Station Design and Precinct Plan – Artarmon Substation

City & Southwest Chatswood to Sydenham project

Project:	Chatswood to Sydenham	Date:	14 May 2021
Group:	C&SW SEP	Status:	Final
Author:	Julieanne Boustead	Revision:	I
Company:	Systems Connect	File number:	SMCSWLWC-SYC-ATS-EM-PLN-003788
File name:	Station Design and Precinct Plan (SDPP) - Artarmon Substation

Objection to Station Design and Precinct Plan (SDPP) – Artarmon Substation

Figure 4: Plan Artarmon Substation, Barton Rd, Chatswood-Sydenham May-June 2016 EIS summary

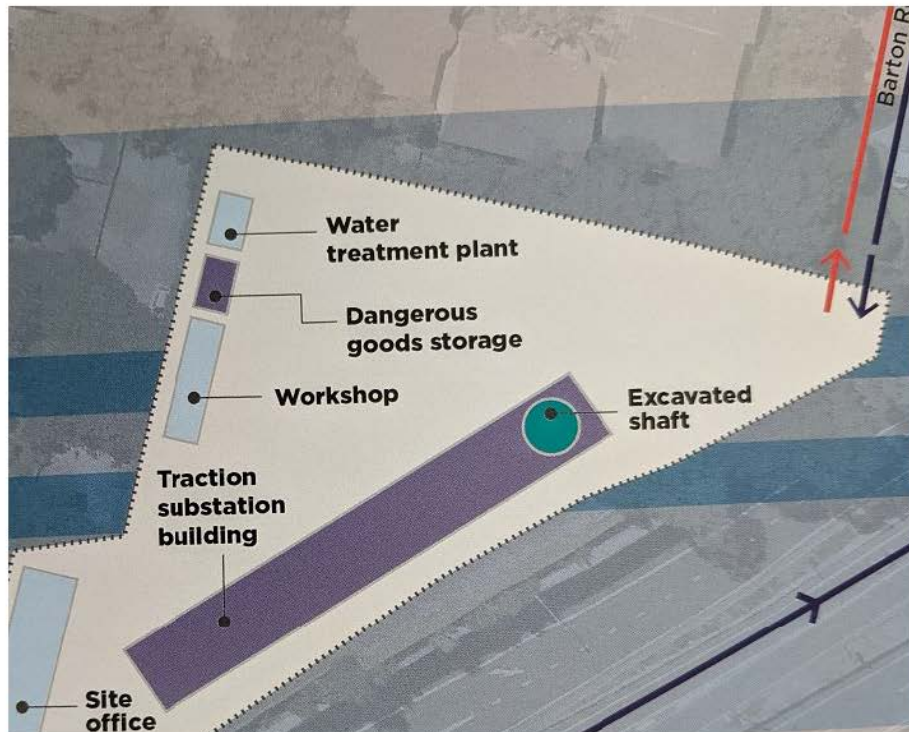
It is also out of character with the images of the Substation as depicted in the Chatswood to Sydneyham May-June 2016 EIS Summary (Figures 4 and 5). These figures show a well-designed single building with a sparse fence that cannot be used as a graffiti billboard.

If a fence is used, it should be black with sparse railings on which it is difficult to display an image as per the 2016 EIS Summary (Figure 5). Such fences are used for many TfNSW projects.

Figure 6 – Western Harbour Tunnel and Warringah Freeway Upgrade March 2020

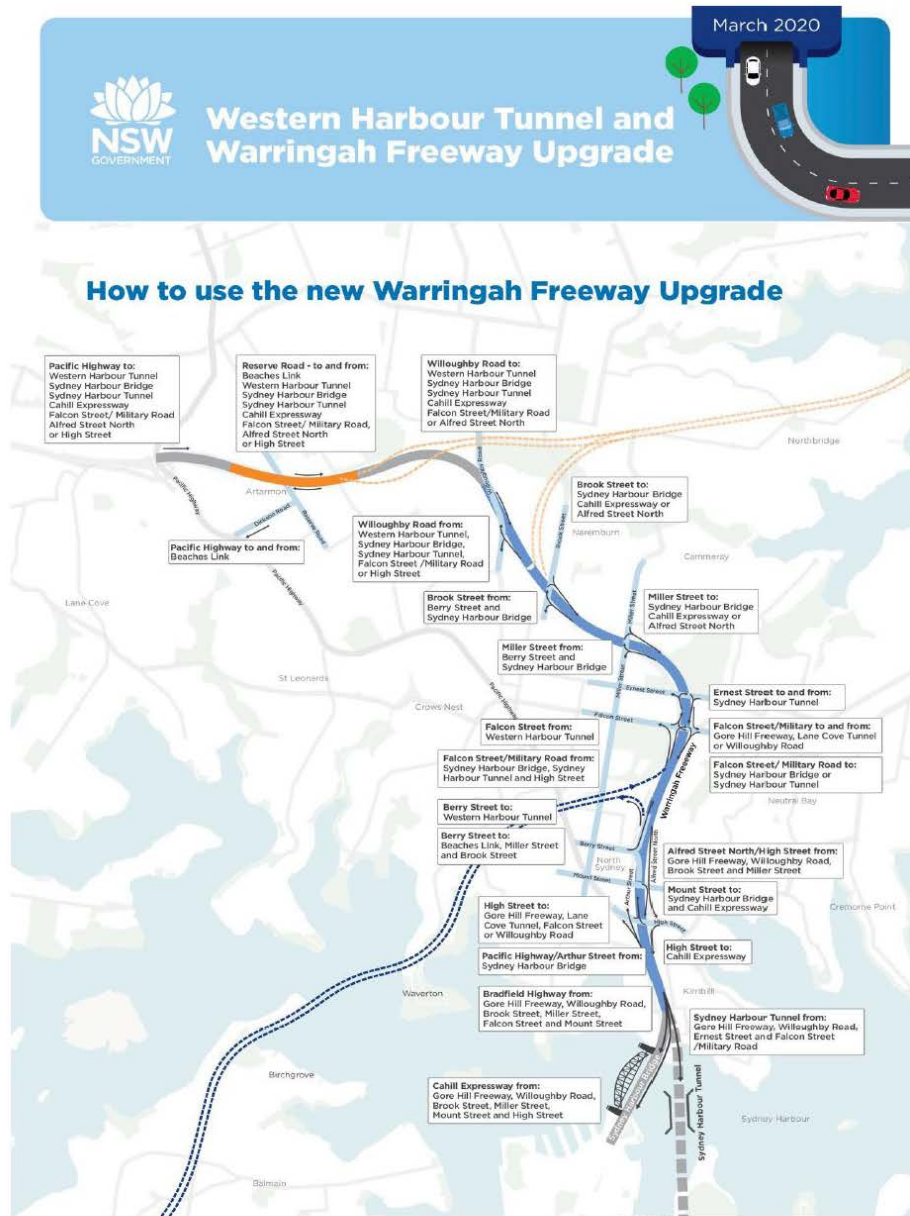
The SDPP was completed 30 April 2017, three years before the "Western Harbour Tunnel and Warringah Freeway Upgrade March 2020" illustration (Figure 6) was released by TfNSW.

The substation plan has not been updated to eliminate the conflict which otherwise reduces the Reserve Rd footpath width from 3.66 metres to 1.86 metres.

Figure 7 – Reserve Road widening for Beaches Link project

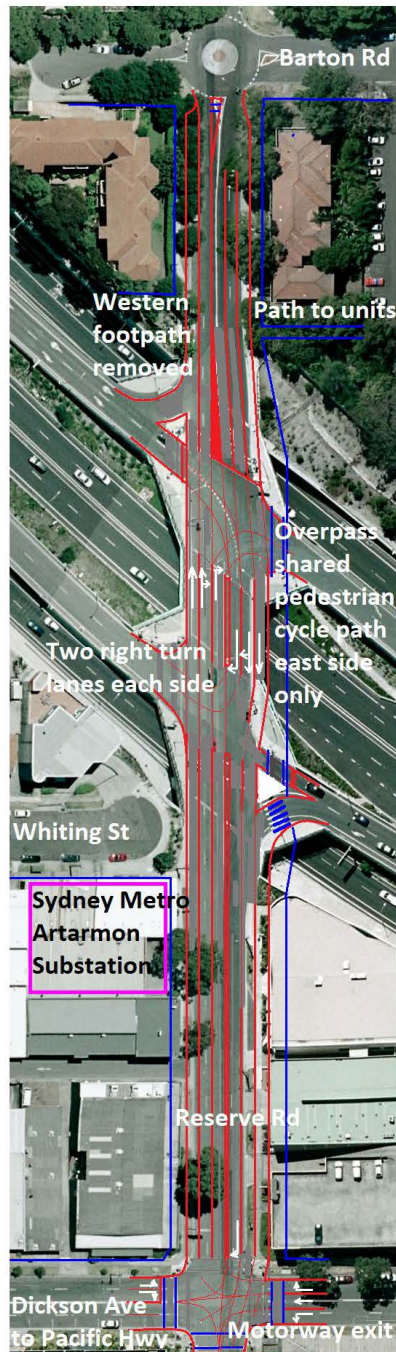
The westward shift of the roadway by 1.8 m needs to apply between Barton Rd and Dickson Ave due motorway ramp layout, Reserve Rd congestion, and the current poor Level of Service rating of 'F' for the Barton Rd and Dickson Ave intersections. Figure 7 provides an illustration of the likely layout of Reserve Rd between Dickson Ave and Barton Rd.

Figure 4: Plan Artarmon Substation, Barton Rd, Chatswood-Sydenham May-June 2016 EIS summary

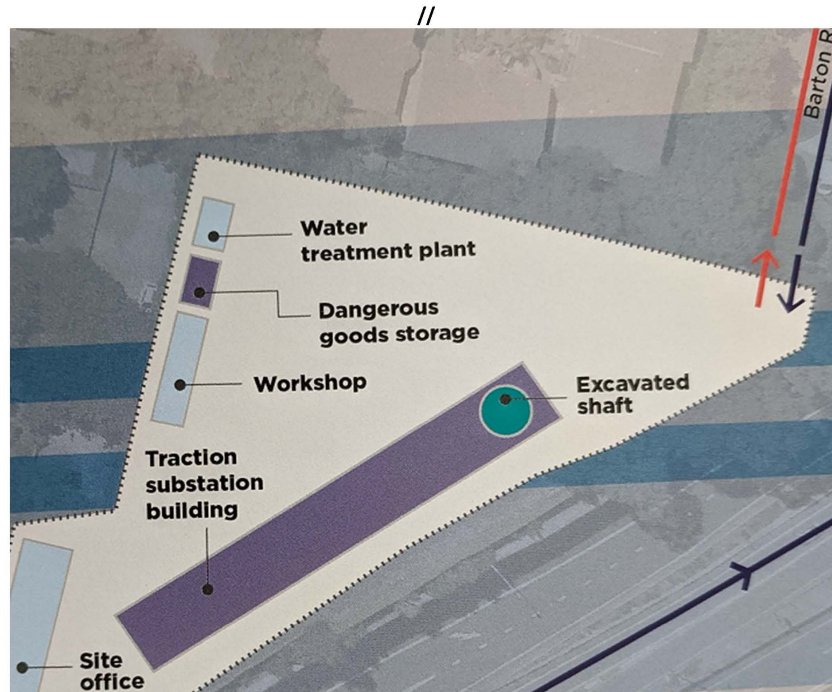
It is also out of character with the images of the substation as depicted in the Chatswood to Sydenham May-June 2016 Environmental Impact Statement Summary (EIS) (Figures 4 and 5). These figures show a well-designed single building with a sparse fence that cannot be used as a graffiti billboard.

If a fence is required it should be black with sparse railings, similar to the one included in the 2016 EIS Summary (Figure 5). Such fences are difficult to imprint an image or tag and are used for many TfNSW projects.

Figure 6 – Western Harbour Tunnel and Warringah Freeway Upgrade March 2020

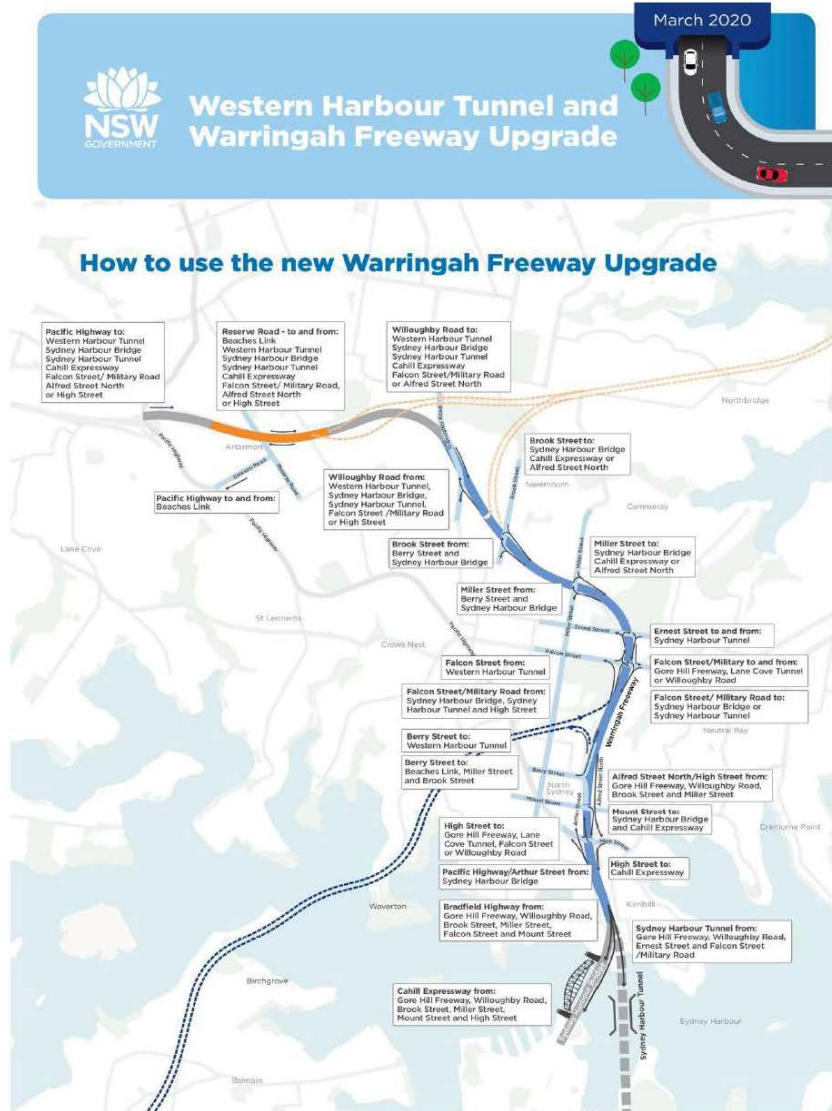
The Station Design and Precinct Plan (SDPP) was completed on 30 April 2017, three years before the "Western Harbour Tunnel and Warringah Freeway Upgrade March 2020" illustration (Figure 6) was released by TfNSW.

Figure 7 – Reserve Rd widening for Beaches Link project

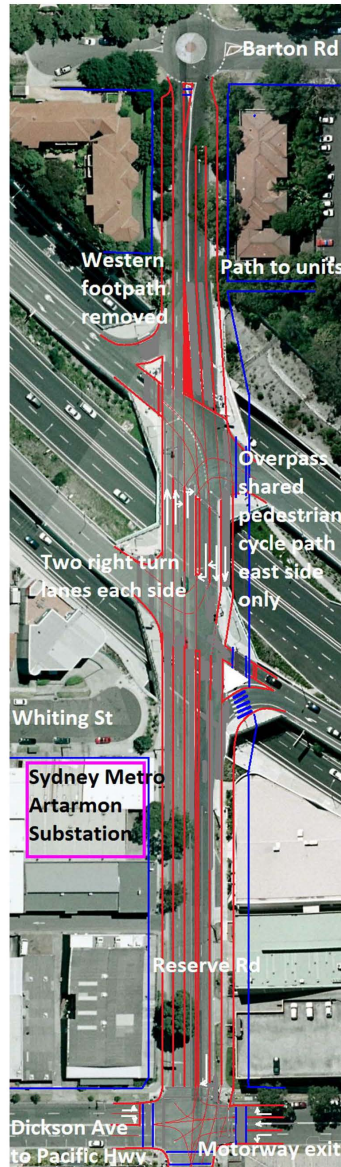
The westward shift of the Reserve Rd roadway by 1.8 m needs to apply between Barton Rd and Dickson Ave due to the motorway ramp layout, Reserve Rd congestion, and the current poor Level of Service rating of 'F' for the Barton Rd and Dickson Ave intersections. Figure 7 provides an illustration of the likely layout of Reserve Rd between Dickson Ave and Barton Rd.
